DONALD C. COOK NUCLEAR PLANT

INDIANA AND MICHIGAN ELECTRIC COMPANY
DONALD C. COOK NUCLEAR PLANT
INSTRUCTION AND PROCEDURE CHANGE SHEET

INSTRUCTION OR PROCEDURE NO.: PMP 2081.EPP.029 REVISION NO.: 0 CHANGE SHEET NO.: 1

TITLE: INITIAL CORE DAMAGE ASSESSMENT

POST ACCIDENT SAMPLE DILUTION
CORRECTION CURVE

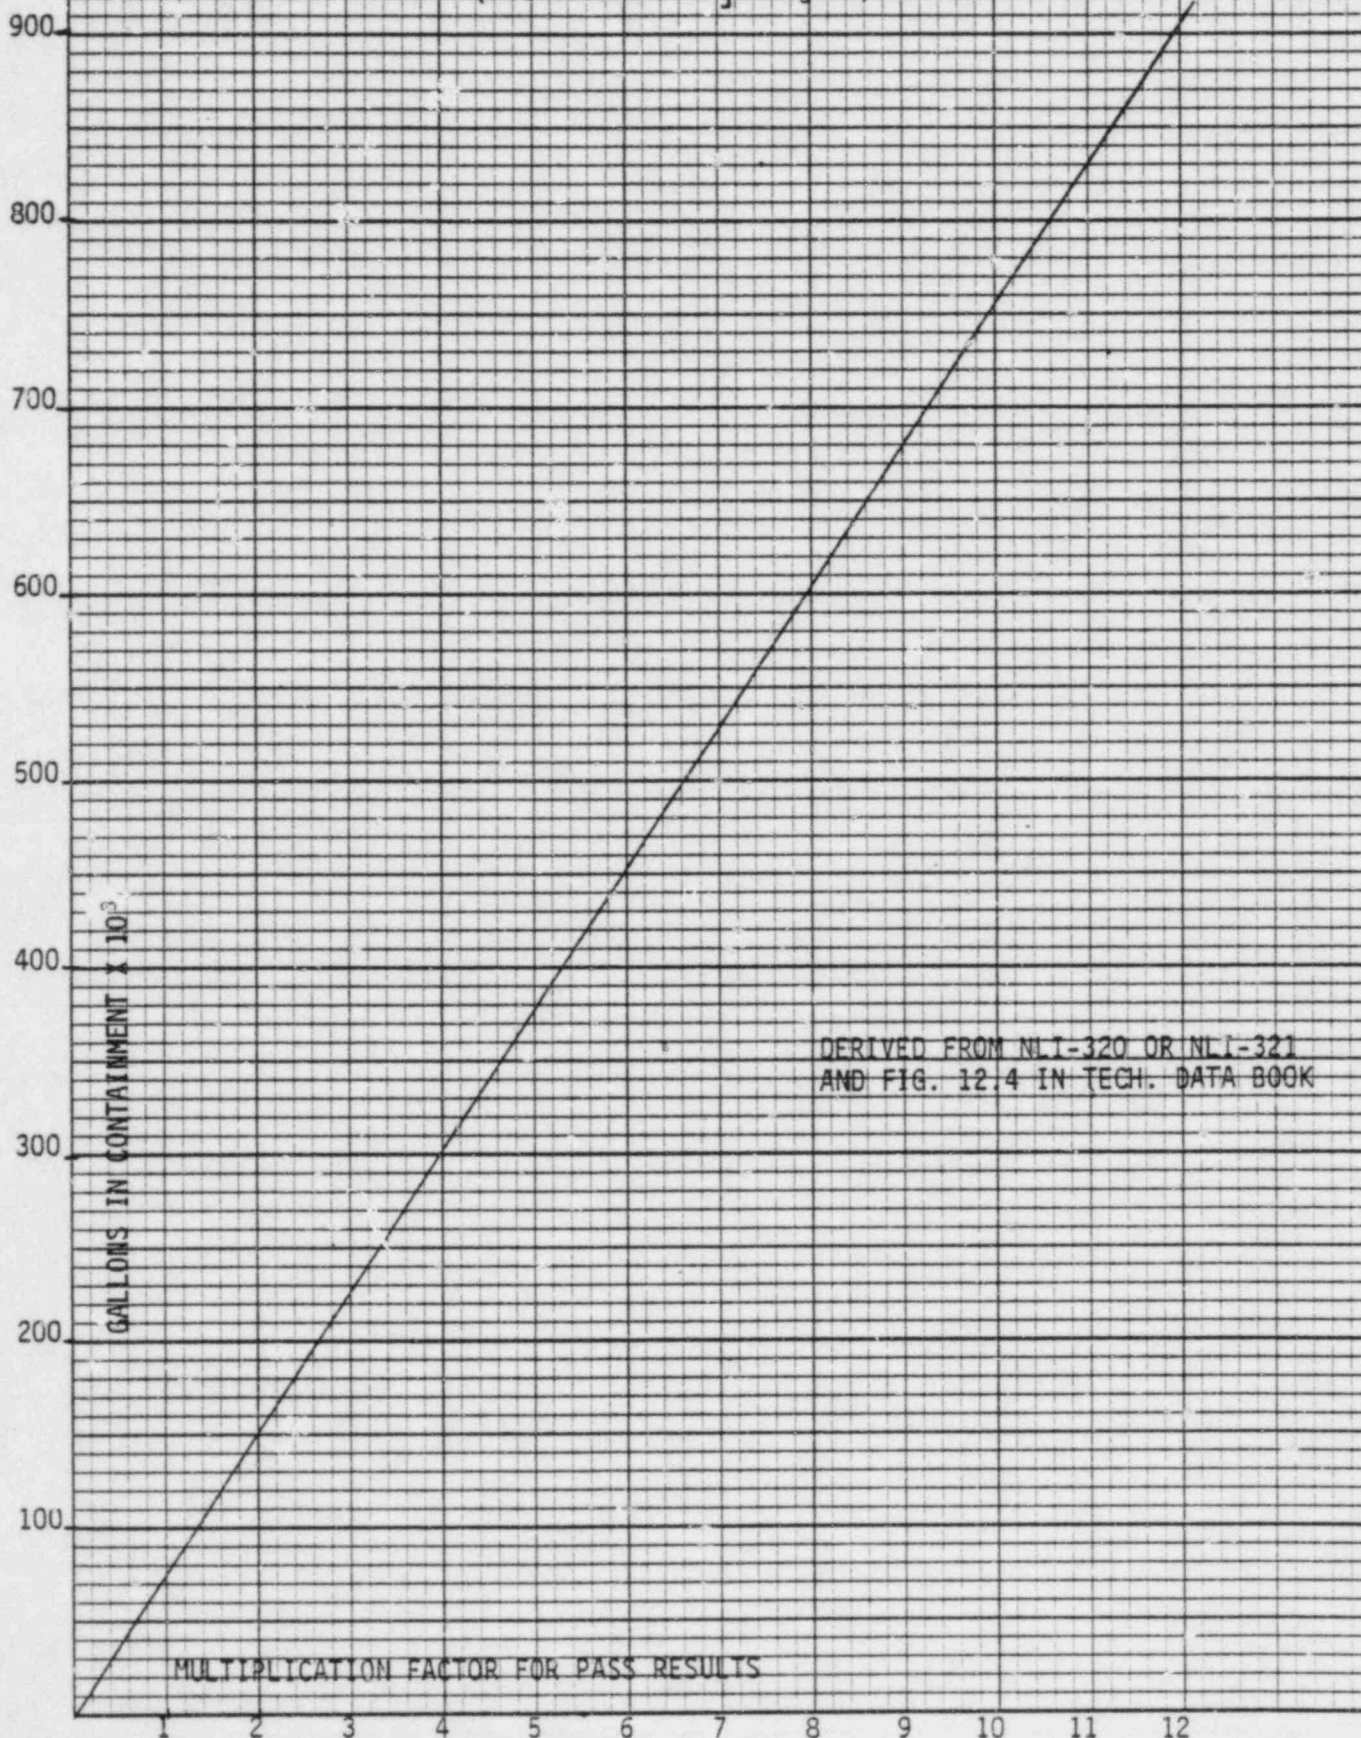
If the reactor coolant system is incapable of maintaining pressure during a LOCA, use of the PASS for coolant system and/or RHR samples may not be possible. In such an event, samples of the lower containment

volume may be collected via the PASS, and sample activity results must be corrected for dilution by use of form 2081.EPP.029 Exhibit E.

Correction of containment sump samples for dilutions during post accident conditions.

Incorporate dilution factors involved in P.A.S.S. use.
